REACTOR COOLANT SYSTEM

STEAM GENERATORS

LIMITING CONDITION FOR OPERATION

INSERT NEW T. S. 3.4.5  
LIMITING CONDITION FOR  
OPERATION, AS ATTACHED

Figure 3.4-5  
Maximum Allowable Steam Generator Level  
in MODES 1 and 2

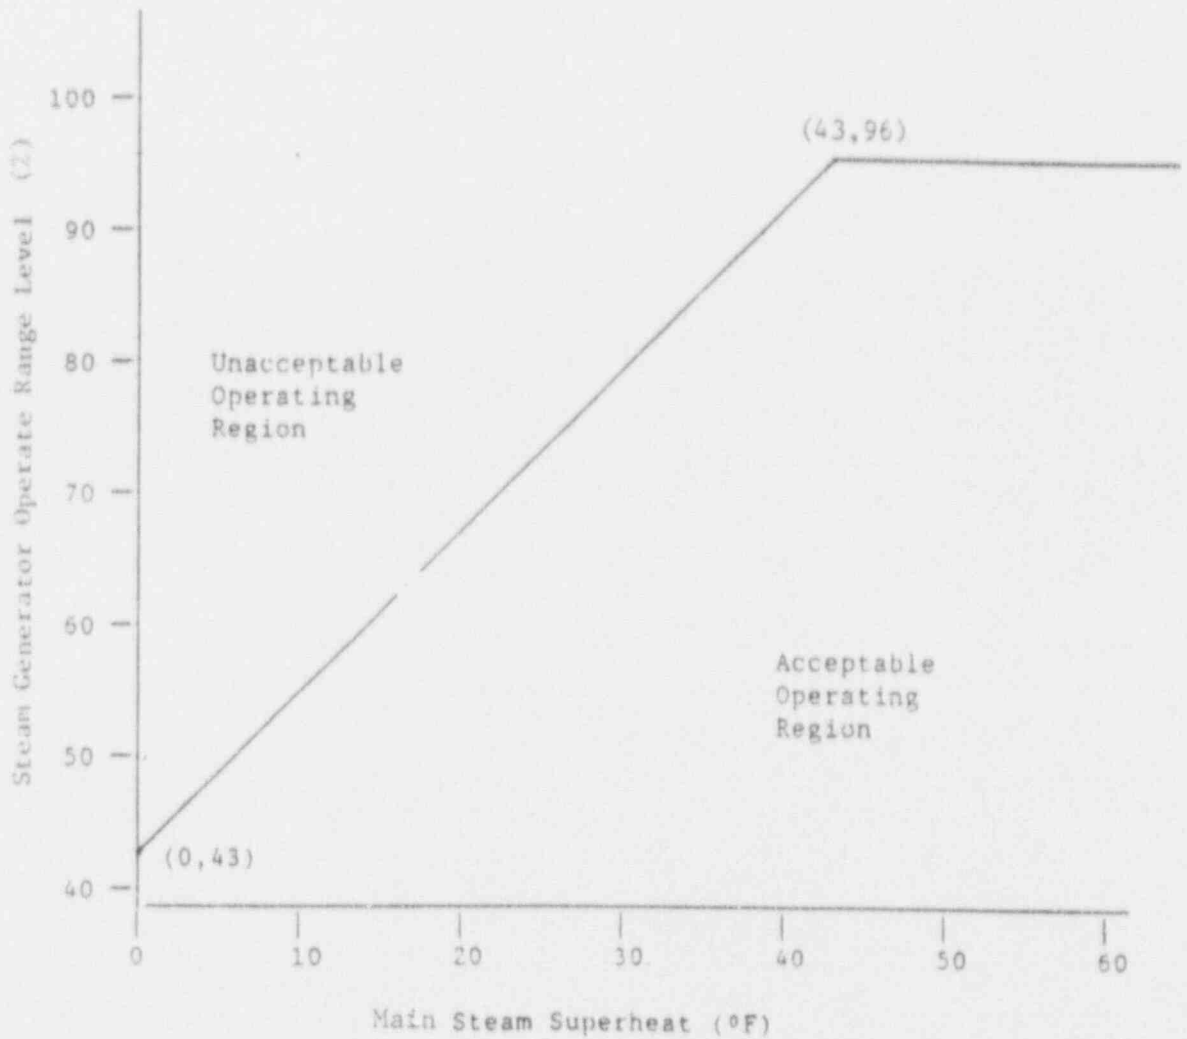
~~3.4.5 Each steam generator shall be OPERABLE with a water level between 18 and 348 inches~~

- a. The acceptable operating region of Figure 3.4-5.

NEW Figure 3.4-5 TO BE INSERTED  
AS NEW PAGE 3/4 4-6 a

3.4.5 Each Steam Generator shall be OPERABLE with a minimum water level of 18 inches and the maximum specified below as applicable:

MODES 1 and 2:
